## Commission of Architectural Review

| 10. COA-178096-2026  | Final Review   | Meeting Date: 2/24/2026 |
| Project Description  | Construct a one story rear addition  |                         |
| Address: 319 North 32nd Street   |  |                         |

Figure 2: Parcel mapper sketch of 319 N 32<sup>nd</sup>, showing the current 5x12 ft rear porch

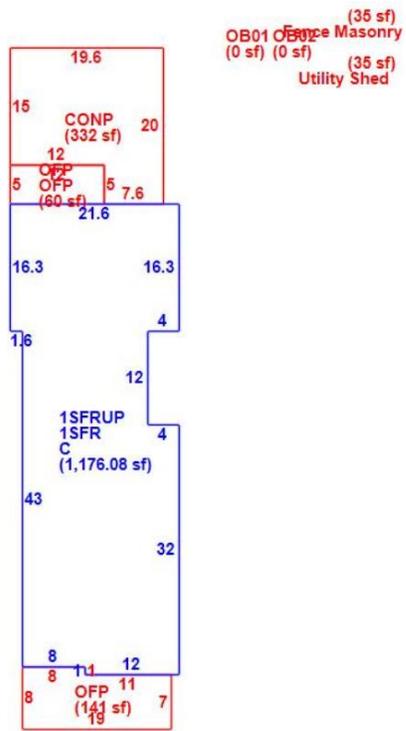
| Guideline Reference   | Reference Text  | Analysis   |
|---|---|--|
| Standards for New Construction, Siting, pg. 46              | <p><i>1. Additions should be subordinate in size to their main buildings and as inconspicuous as possible. Locating additions at the rear or on the least visible side of a building is preferred.</i></p>  | <p>Historic mapping indicates that the rear porch is a later addition to the building and is not part of the original historic construction. A comparison of the 1925 Sanborn Fire Insurance Map with current parcel sketches shows that the original building footprint did not extend to the rear porch area. As such, the proposal involves the alteration and partial demolition of non-original historic fabric, rather than historic material. The scope is also limited to alterations to the rear elevation, which is suitable as per the Guidelines.</p> <p><u>Staff recommends approving the partial demolition and enclosure of the rear porch.</u></p>   |
